PROJECT: Webster University - Interdisciplinary Science Building
ENGINEER: Cannon Design
DESCRIPTION: Linear Slot Supply, 1" Slot
SDS100//I/48.000/3/14//I/ZZ//B12

Shop Drawing Submittal Review

Project Name: Webster University-**ISB**

Copies	No.	Description
1 PDF	238800M08	(Submittal No.'s:) (R&B-CxSRC)
		(Cannon #238800-11) - (Paric #15051-0370) - (WES #607)
		➤ Air Distribution – Price Air Devices

SDS100 1" Slot Linear Supply

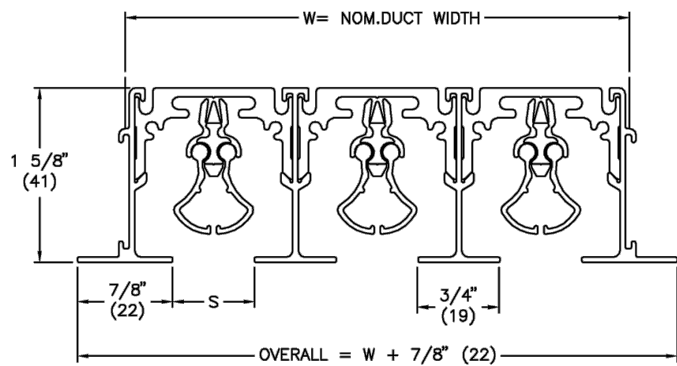
1. Confirm device quantities.
2. Verify ceiling construction with frame types.
